Crystal River Nuclear Plant
Docket No. 50-302
Operating License No. DPR-72

Subject: Crystal River Unit 3 – Response to Request for Additional Information on the Third 10-Year Inservice Inspection Interval Requests for Relief 09-001-II, 09-002-II and 09-003-II (TAC NO. ME0905, ME0906 and ME0907)

RESPONSE TO REQUEST FOR ADDITIONAL INFORMATION

Figure 23

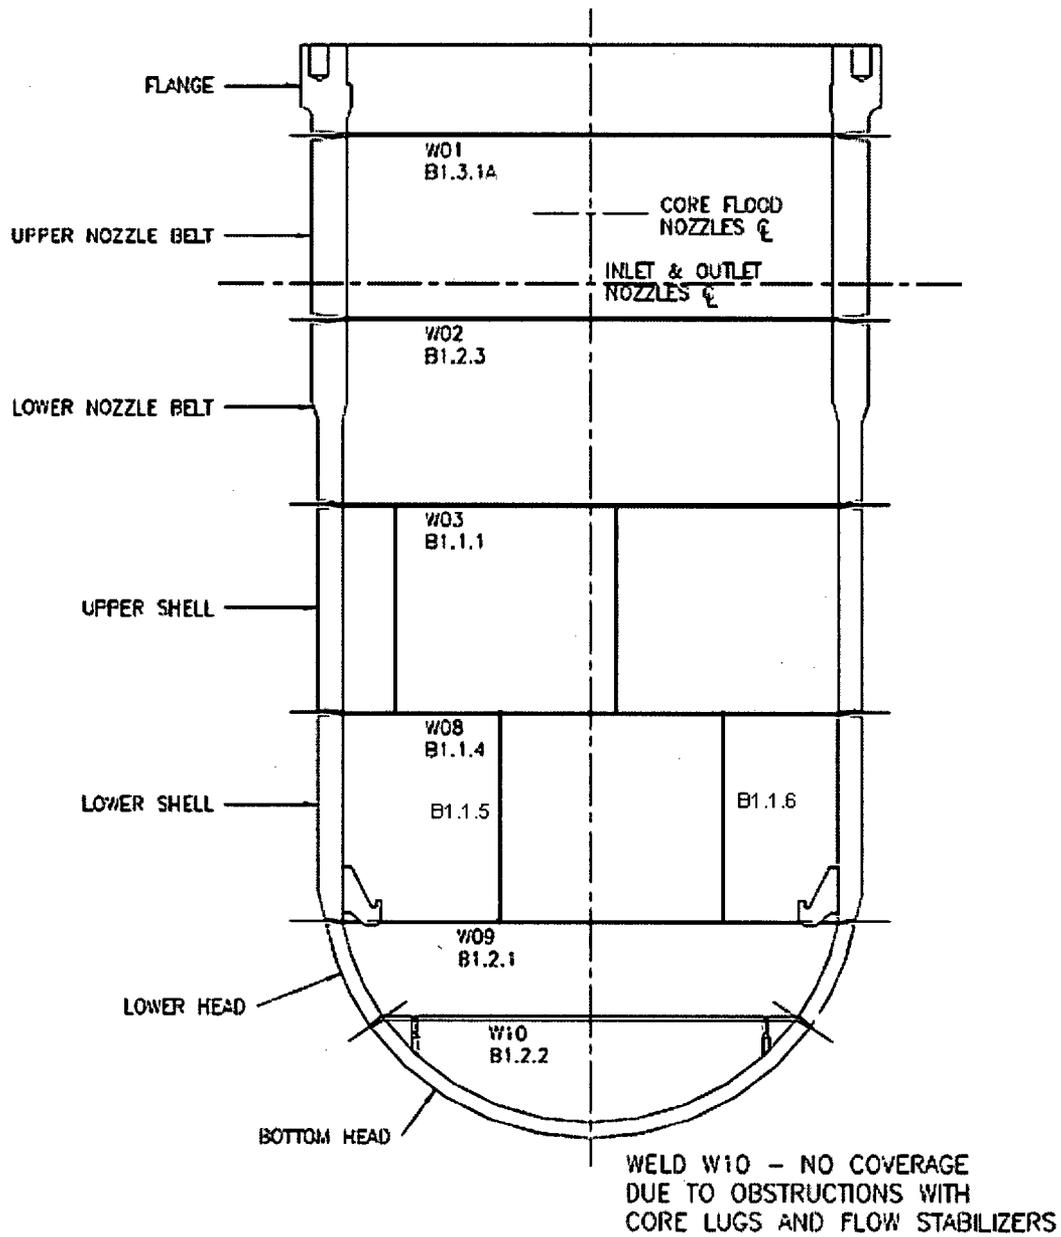
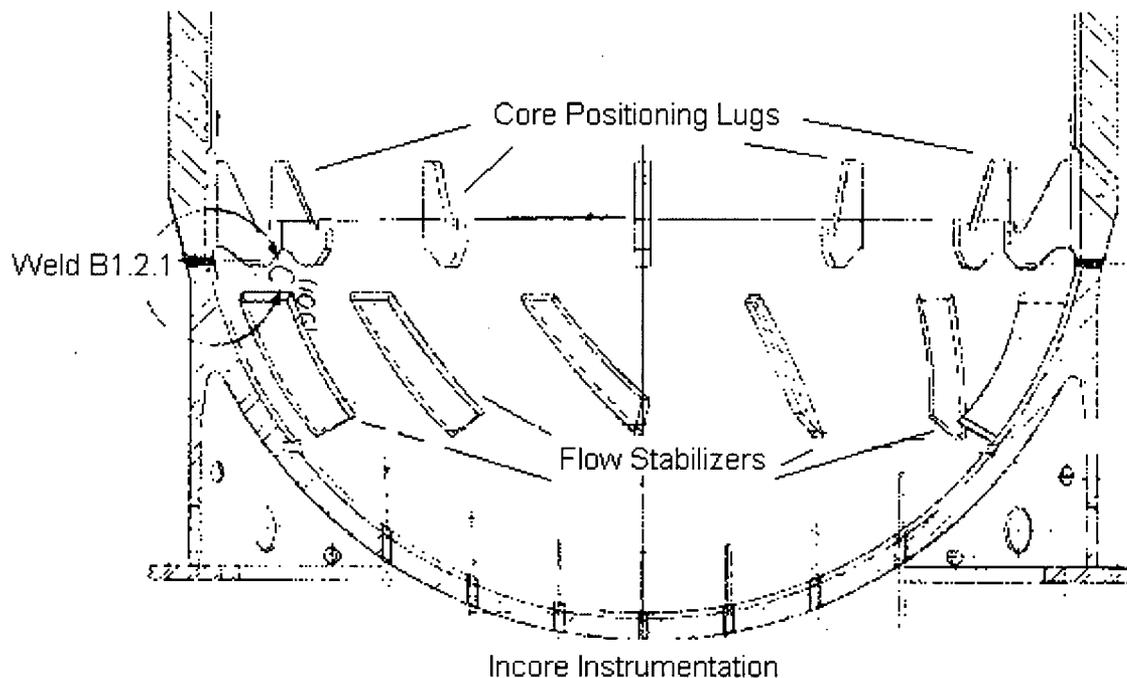
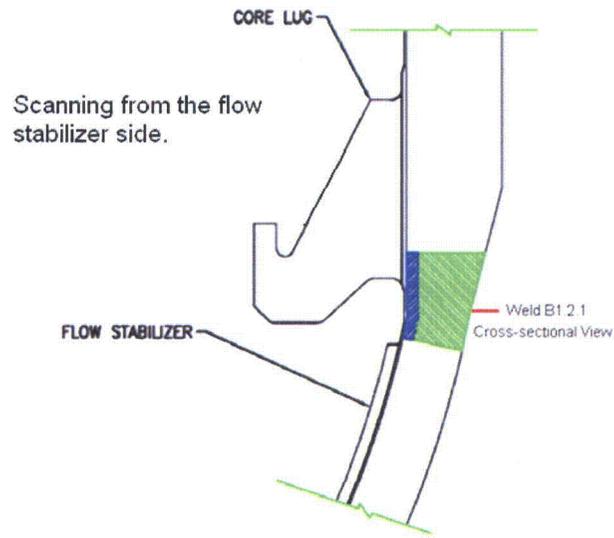
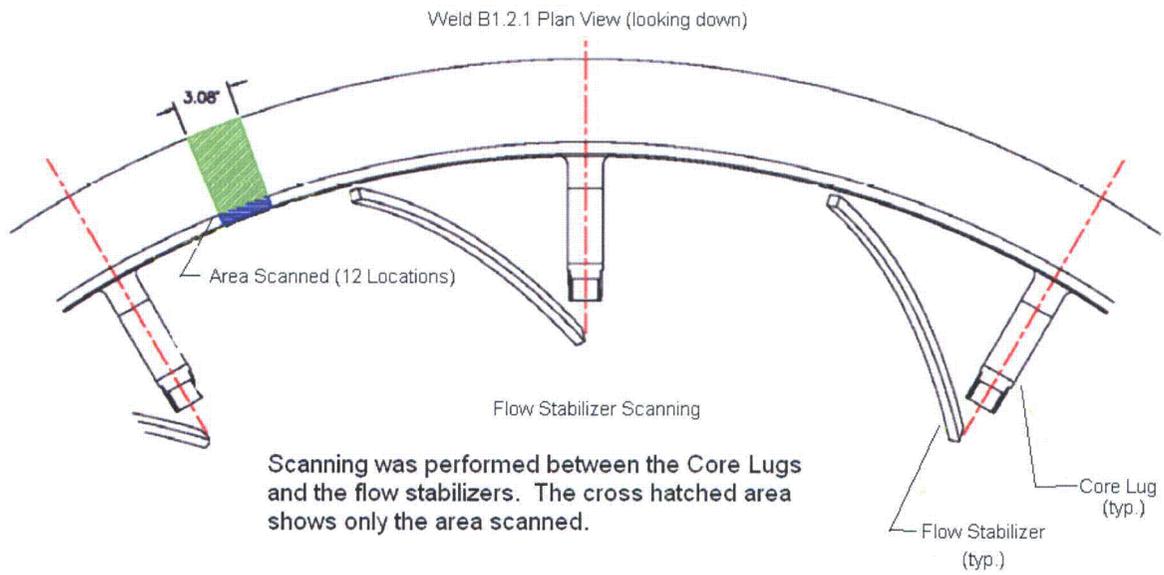
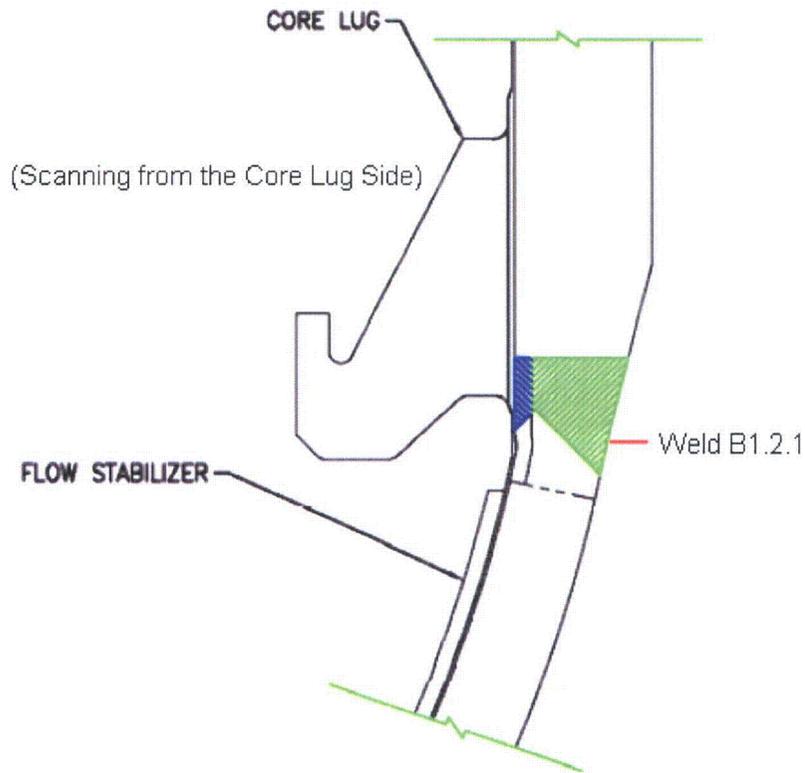
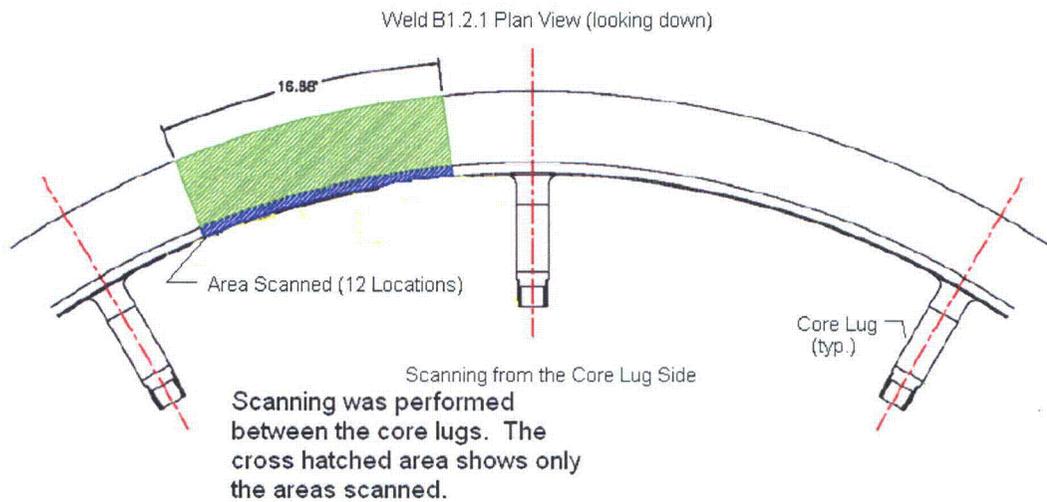
2.6.1 In Attachment A and B of Enclosure 3, the licensee has included multiple sketches and tables with volumetric coverage percentages at different angle beam orientations and arrangements. However, the sketches included are of poor quality and generally unclear, and do not adequately demonstrate impracticality and volumetric coverage(s) achieved. Please clearly explain the limiting conditions and completed percentages of the ASME Code volumes examined. Include in your response the ultrasonic angles applied and include dimensions and scanning directions. Please submit and refer to the cross-sectional drawings, if needed for providing the above clarification. Also, discuss whether alternative methods or advanced technologies could be employed to maximize ASME Code coverage.

Weld B1.2.1 (Figures 23 and 24 for weld location) was scanned using 45° and 70° longitudinal waves for the inner 15% and 45° longitudinal and shear waves for the outer 85% of the weld volume in two parallel and two perpendicular directions to the weld. The total coverage of the Code Required Volume was 46% and was calculated using an aggregate of all scans.

The weld is limited by flow stabilizers and core positioning lugs (Figures 24 through 28 for positioning of the core lugs and stabilizers in relation to the weld). The scan limitation is a physical limitation which would also impact alternative methods or advanced technologies. Radiography as an alternative is not feasible because access is not available for film placement. No alternative examinations or advanced technologies were considered capable of maximizing ASME code coverage further for the weld during the current inspection interval.

Figure 30

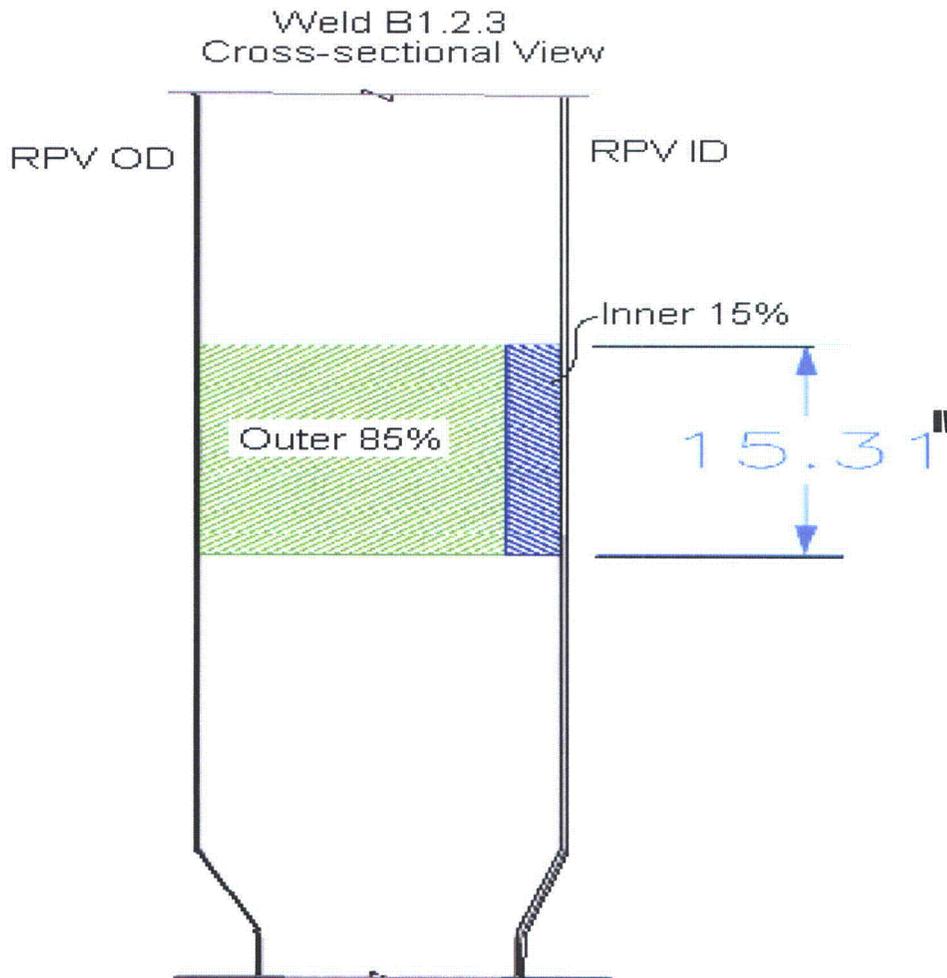
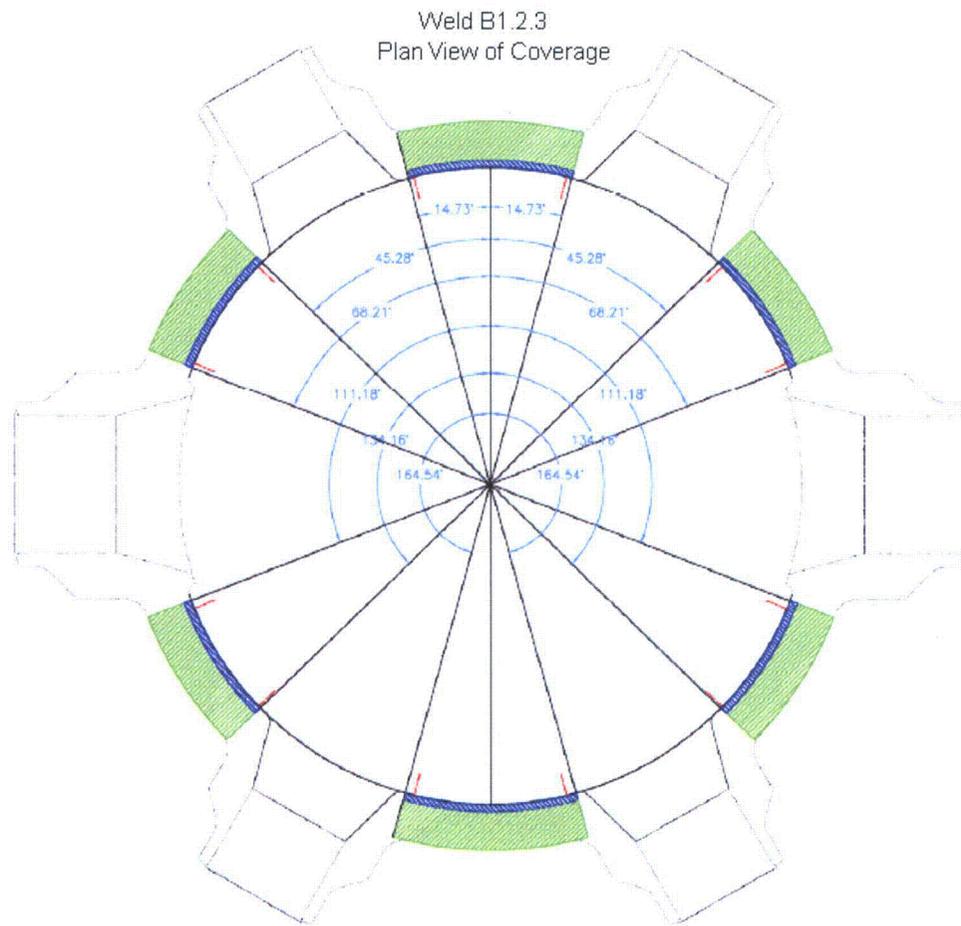
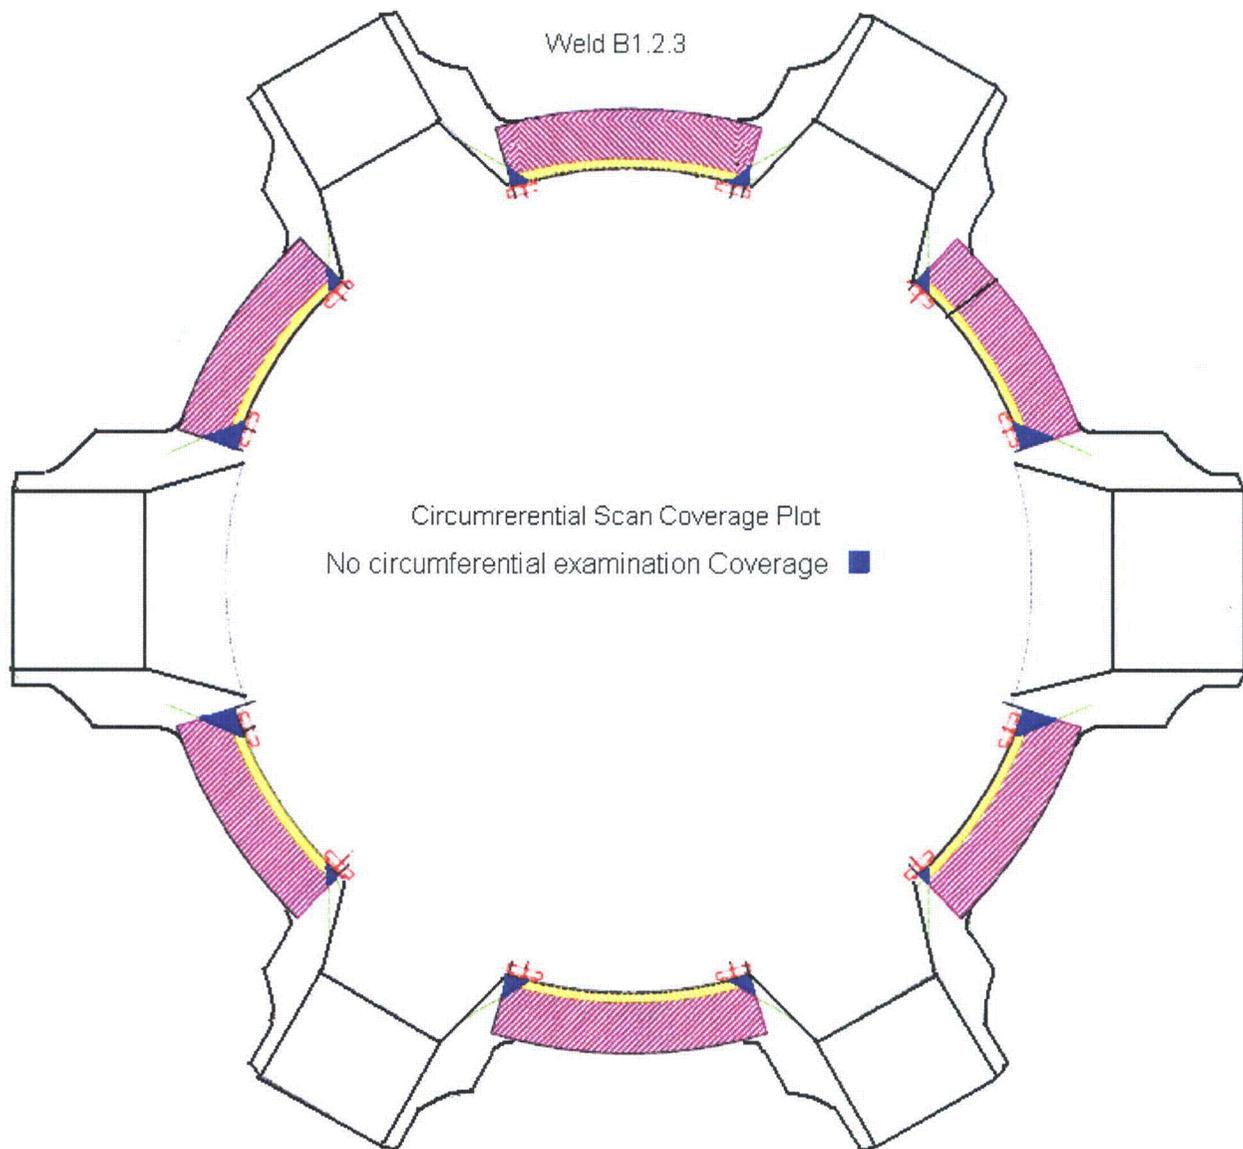
2.6.2 Please report whether any indications were detected for the third ten-year ISI examination for the RPV nozzle belt intermediate shell Weld (B1.2.3).

Weld B1.2.3 (Figure 23 for weld location) was scanned using 45° and 70° longitudinal waves for the inner 15% and 45° longitudinal and shear waves for the outer 85% of the weld volume (Figure 30) in two parallel and two perpendicular directions. The total coverage was calculated using an aggregate of all scans. Refer to Figures 30, 31 and 32 for cross-sectional view and plan views of axial and circumferential scan coverages. During the Third Ten-Year Interval examination, a total of 90 percent of the weld was examined. The remaining ten percent was not accessible due to scanning interferences

with the inlet nozzle openings and the outlet nozzle boss extensions (Figures 31, 32, 35, 36, and 37 for representation of nozzle boss limitations). The scan limitation is a physical limitation which would also impact alternative methods or advanced technologies. Radiography as an alternative is not feasible because access is not available for film placement. No alternative examinations or advanced technologies were considered capable of maximizing ASME code coverage further for the weld during the current inspection interval.

There were no recordable indications noted for weld B1.2.3. The circumferential scan was limited by the nozzle configuration for the circumferential scan only.

Figure 35

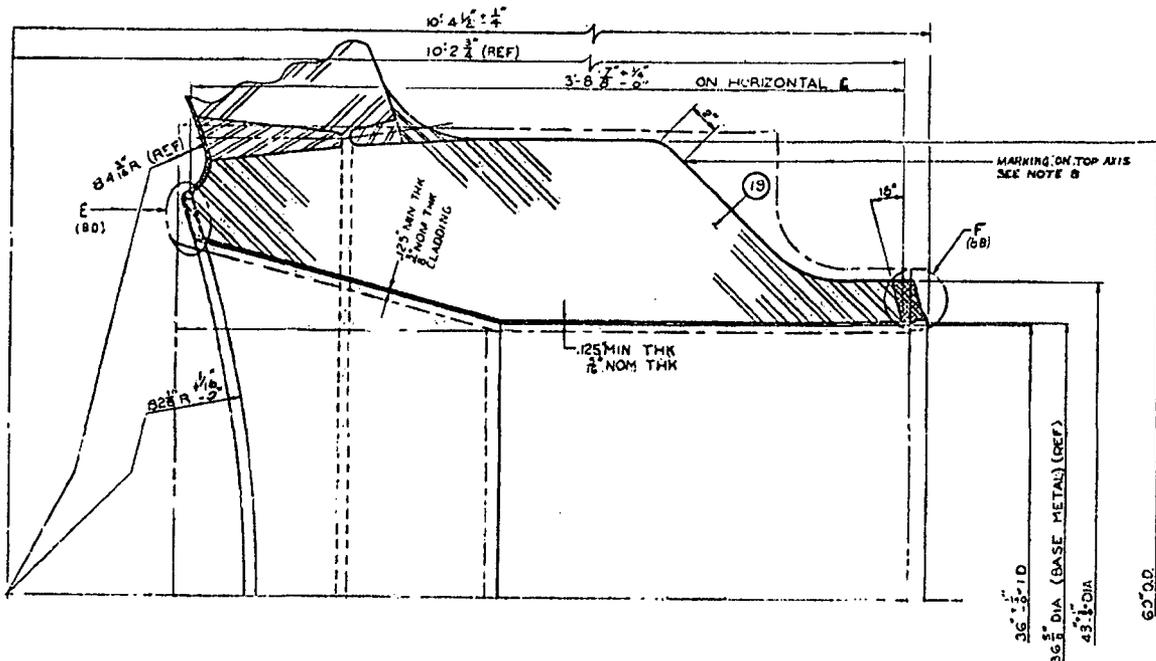
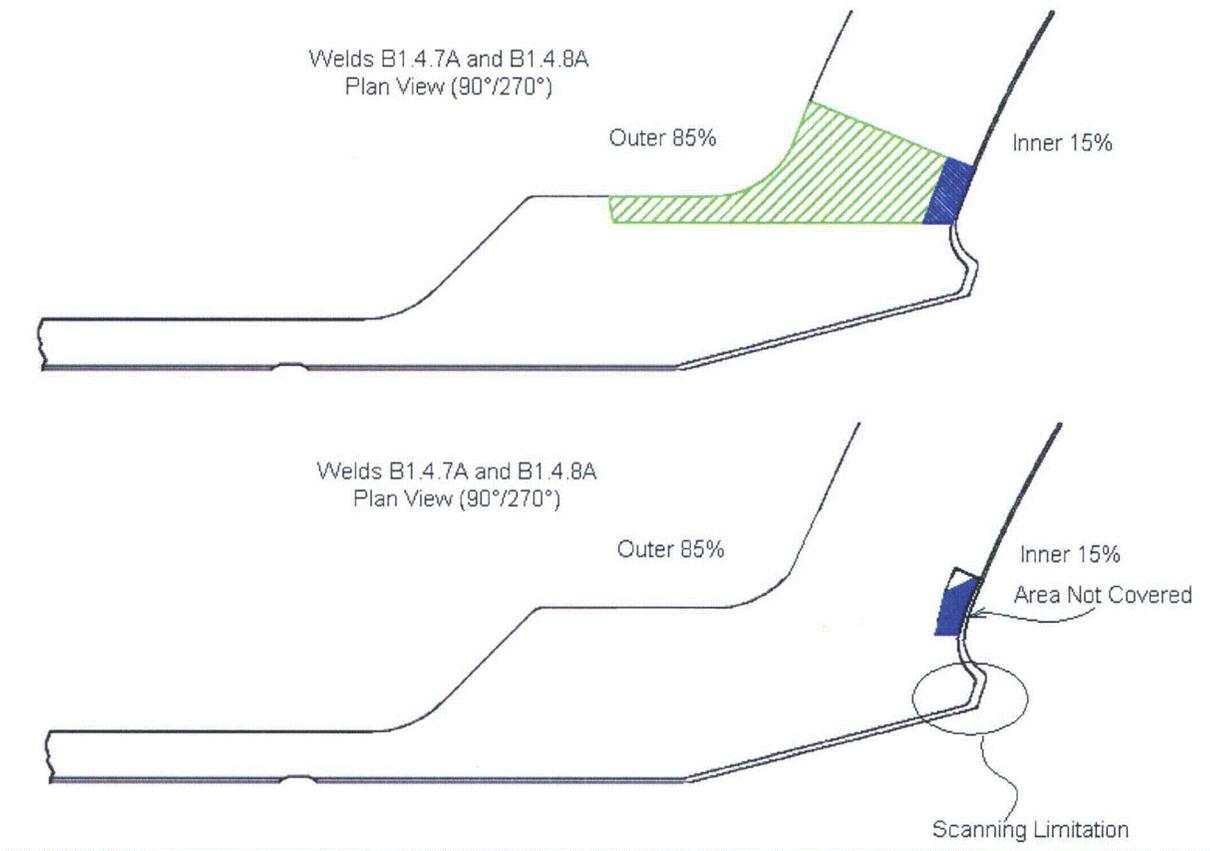
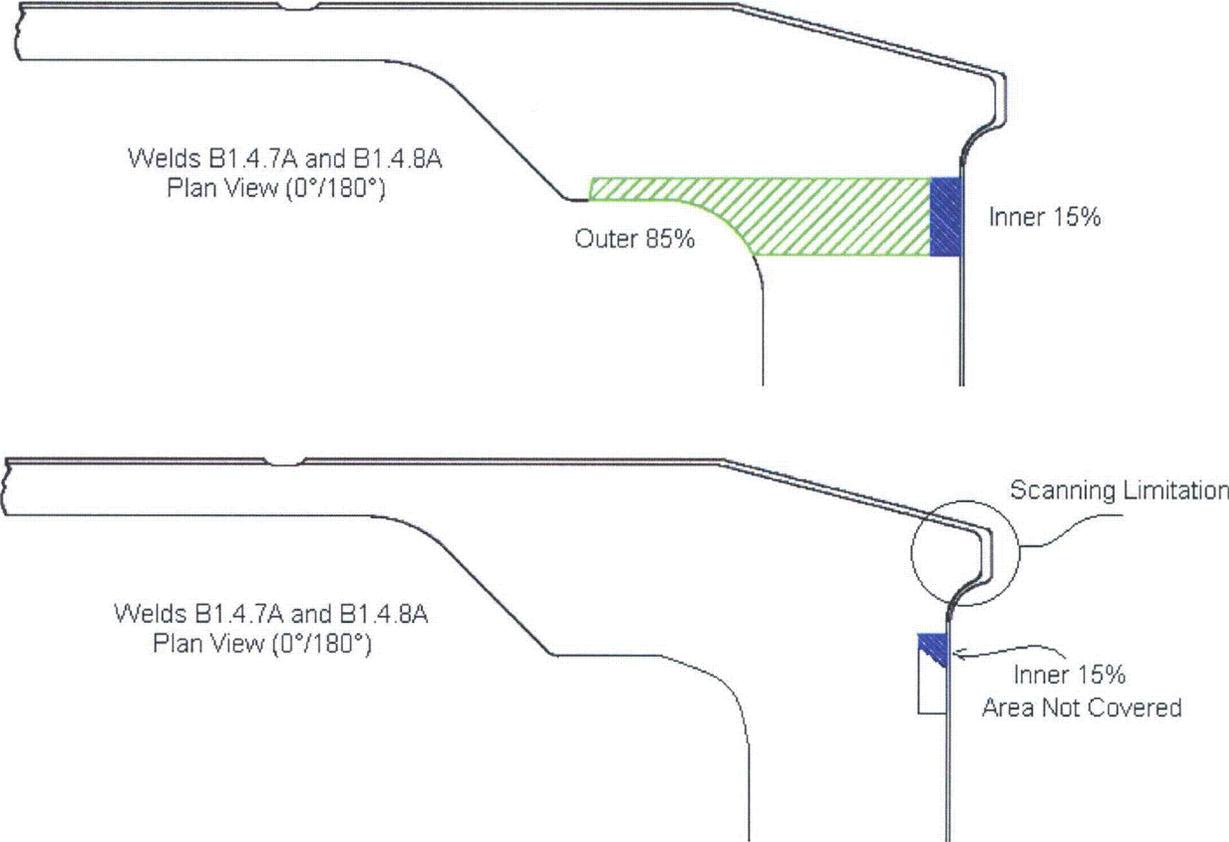
2.7 Request for Relief 09-003-II, Part B, Examination Category B-D, Item B3.90, RPV Nozzle-to-Vessel Welds

Complete redesign of the nozzles would be needed to provide enough clearance so the welds could be examined. Such a re-design is impractical for an installed reactor vessel.
